9.3 Process Auxiliaries

The information in this section of the reference ABWR DCD, including all subsections, tables, and figures, is incorporated by reference with the following departures and supplements.

9.3.2 Process and Post Accident Sampling System

Figure 9.3-10 Breathing Air System Flow Diagram

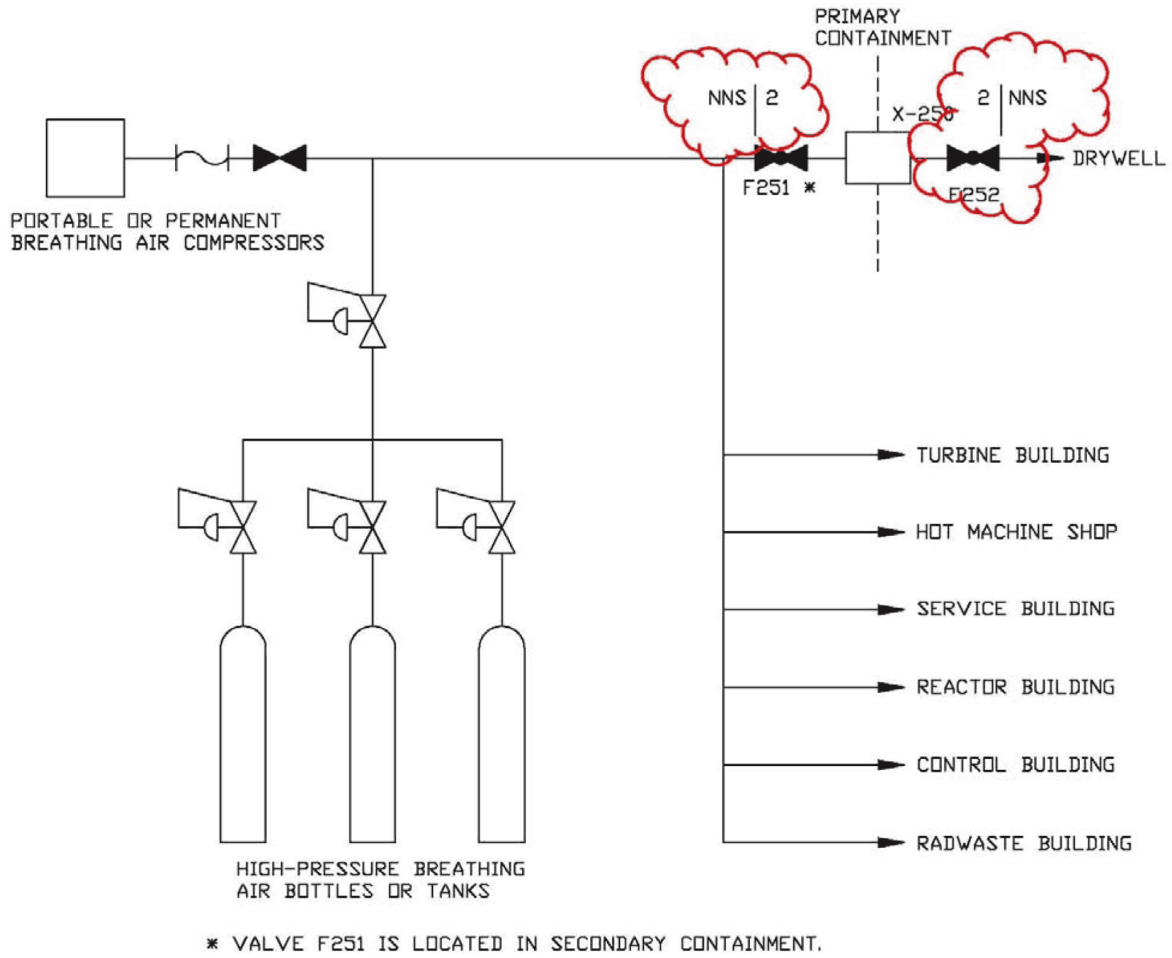
The SAS provides compressed air for tank sparging, filter/demineralizer backwashing, air-operated tools and other services requiring air of lower quality than that provided by the IAS. ~~Breathing air requirements are provided by the SAS.~~ The Breathing Air System (BAS) is discussed in Subsection 9.3.7.6.

The BAS is sized to provide 100% of the peak air consumption using the bottled breathing air supply and a portable permanent breathing air compressor supply system, as needed. The compressor(s) will be of the oil-less, breathing air type.

<u>Pressure (design of BAS)</u>	<u>689 kPaG</u>
<u>Pressure (design of self-contained breathing apparatus charging)</u>	<u>17.23 MPaG</u>
<u>ANSI Compressed Gas Association (CGA) 7.1-1997, "Commodity Specification for Air"</u>	<u>Air Quality Grade D</u>

Figure 9.3-12 Non-Radioactive Drainage System

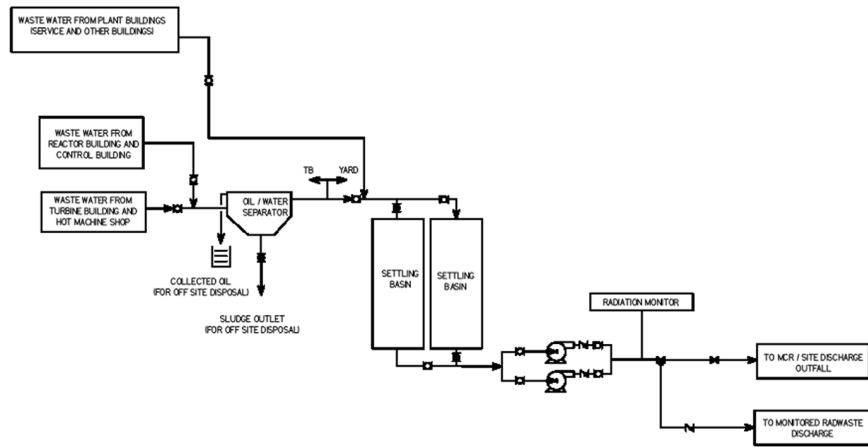
The design of the continuation of the non-radioactive drain system from the ABWR Standard Plant Buildings to the site discharge outfall is provided in Figure 9.3-12 and is discussed in this subsection.

The conceptual design information in this subsection of the reference ABWR DCD is replaced with the following site-specific supplement.

The non-radioactive drain system collects waste water from plant buildings (Reactor, Turbine, Control, Service, and other buildings). A system composed of collection piping, curbs, and pumps is provided. Non-radioactive waste water from the Turbine Building, Reactor Building, hot machine shop and the Control Building is routed to a dedicated oil/water separator where oil and settled solids are removed for off-site disposal. The non-oily, non-radioactive effluent is sent to dual settling basins. Non-radioactive waste water from the Service Building and other buildings is sent directly to the dual settling basins. Means are provided to perform any required tests or analyses required by the discharge permit. The non-radioactive liquid effluent is

discharged to the Main Cooling Reservoir through permitted outfall(s). If radioactivity levels exceed the limits for discharge, the flow from the non-radioactive drains has the capability to be diverted to the radioactive effluent portion of the radwaste system. Normally, if low levels of radioactivity are detected, it is quantified and discharged via the normal outfall. Higher levels of radioactivity may require a permitted "batch" discharge via the radwaste effluent radiation monitor. The non-radioactive drainage system is illustrated in Figure 9.3-12.
